ADDENDUM #04

INVITATION TO BID #01

ALTERATIONS TO
ACES at CHASE
565 CHASE PARKWAY, WATERBURY, CT
STATE PROJECT NO. 244-0044 MAG
DECEMBER 11, 2025

JANUARY 15, 2026

4 CHORUS 201-4 / KEYBOARDING 202-4 - ELEVATION A
1/2" = 1'-0"

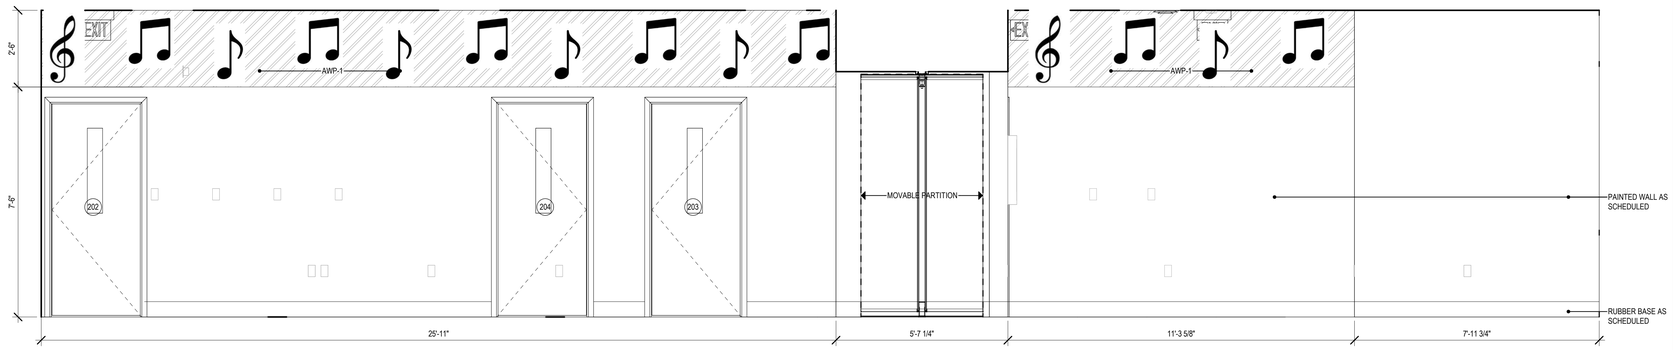
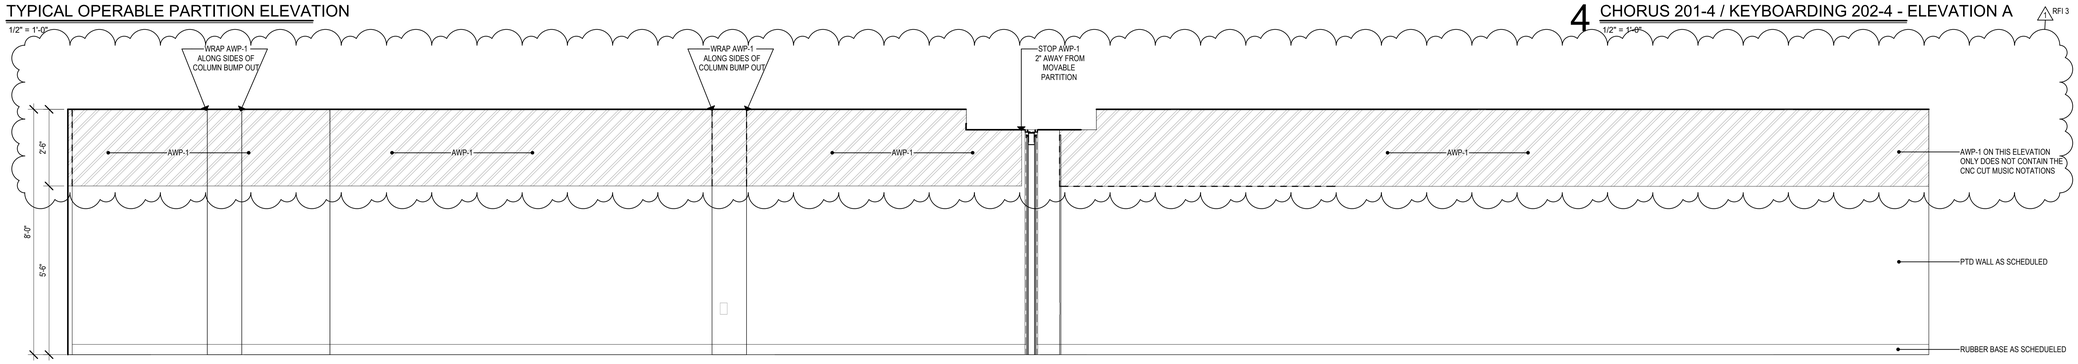
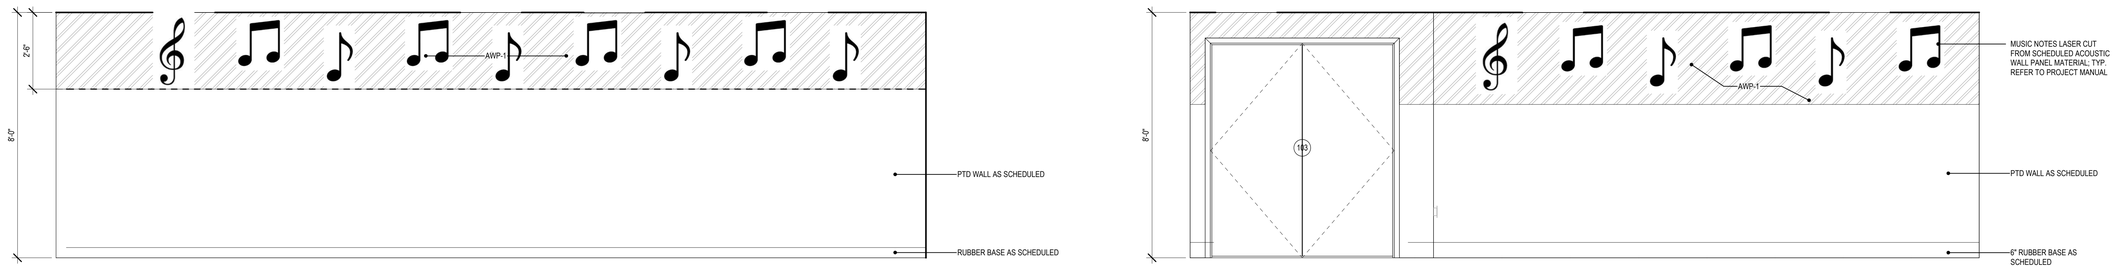
Add Item #70 RFI #3 (Building 4) **Question:** Please confirm if the AWP-1 panels are to be installed behind the lockers in detail 3/A731-4 or should just be in open area above lockers. **Answer:** Refer to Bulletin #2 for revised Drawing A731-4. -S/P+A-KD

Drawing Title: BUILDING 5 - MAIN LEVEL CEILING PLAN
Project Phase: ISSUED FOR BID - 11/03/2025
State Project Number: #244-0044 MAG
Date: AUGUST 12, 2025
Scale: As indicated
Drawn By: MES
Project Number: 22.050
Drawing Number: A220-5

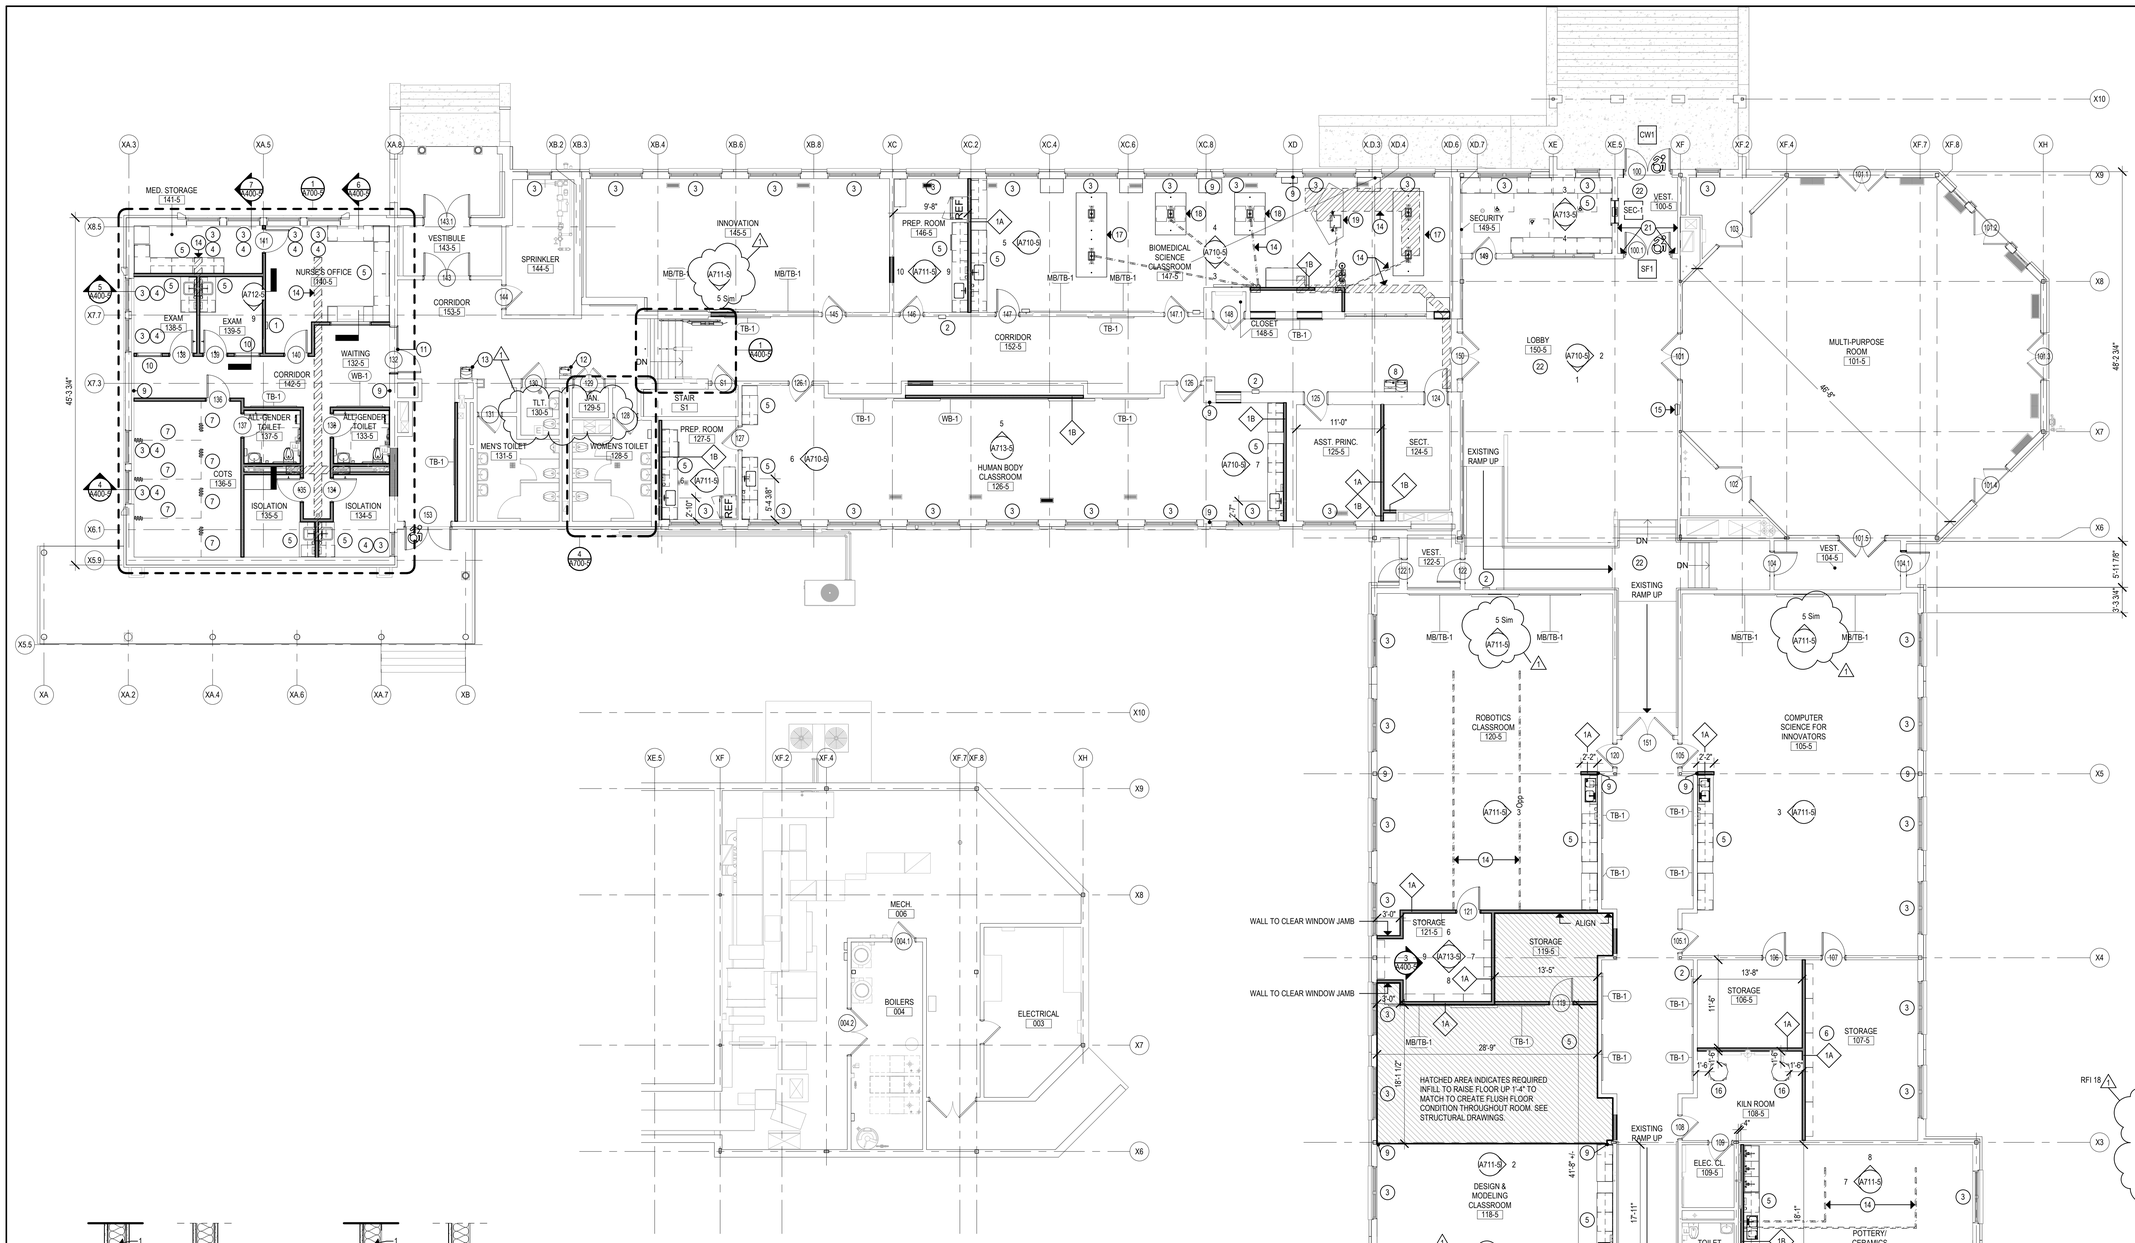
Add Item #72 RFI #1 (Building 5) **Question:** On drawing A220-5 there is a note that states all ceilings with "ETR" ceilings shall be field verified by the contractor. What does this mean for the scope of work? **Answer:** All ceilings labeled ETR are existing to remain & should not be touched unless required to be stored & reinstalled for M/E/P work. Refer to Bulletin #2 for revised Drawing A220-5. -S/P+A-MES

2 LOBBY 150-5 - ELEVATION B

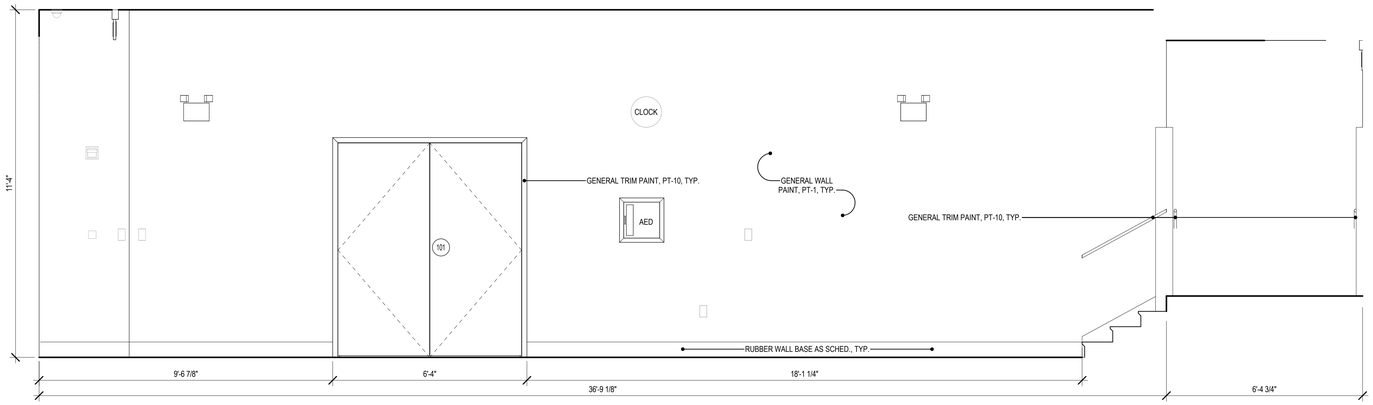
Add Item #64 RFI #39 (General) **Question:** Identify where TGP panels are on finishes? **Answer:** Refer to Drawing A260-5, Lobby 150-5.

2 SCIENCE CLASSROOM PLAN
1/4" = 1'-0"

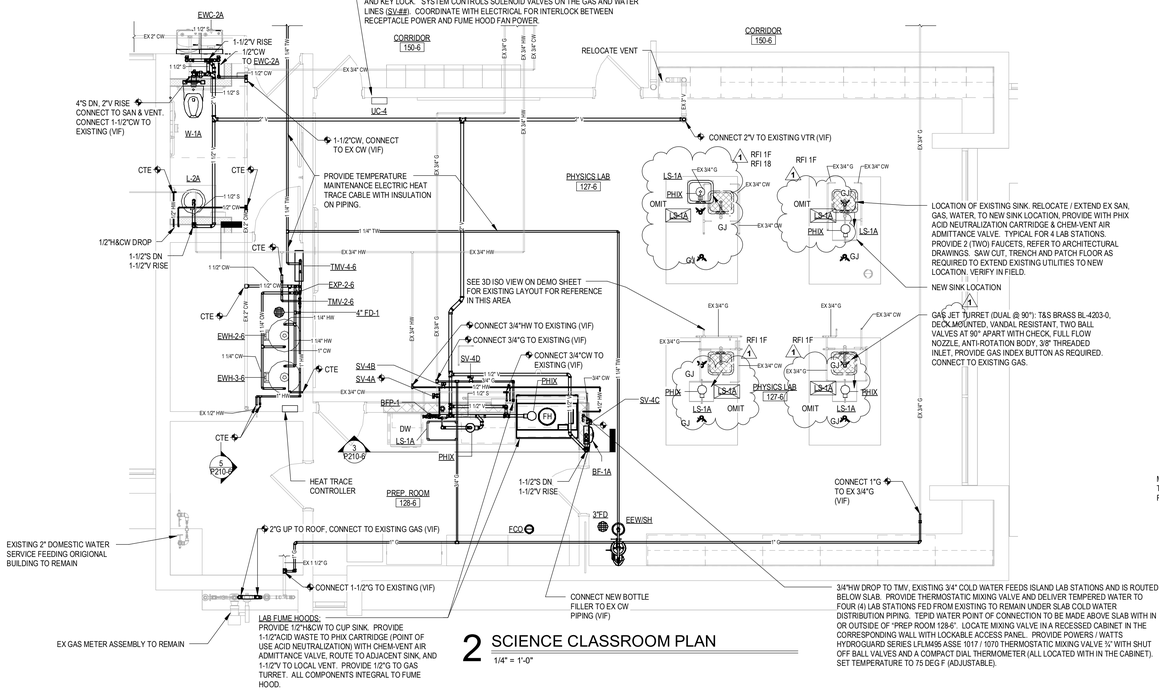
c. Integral sink is correct. Refer to Bulletin #2 for revised Drawing P210-6.
d. Epoxy shelving specified in Section 123553.16 is to be used for shelving in Greenhouse 105-6.
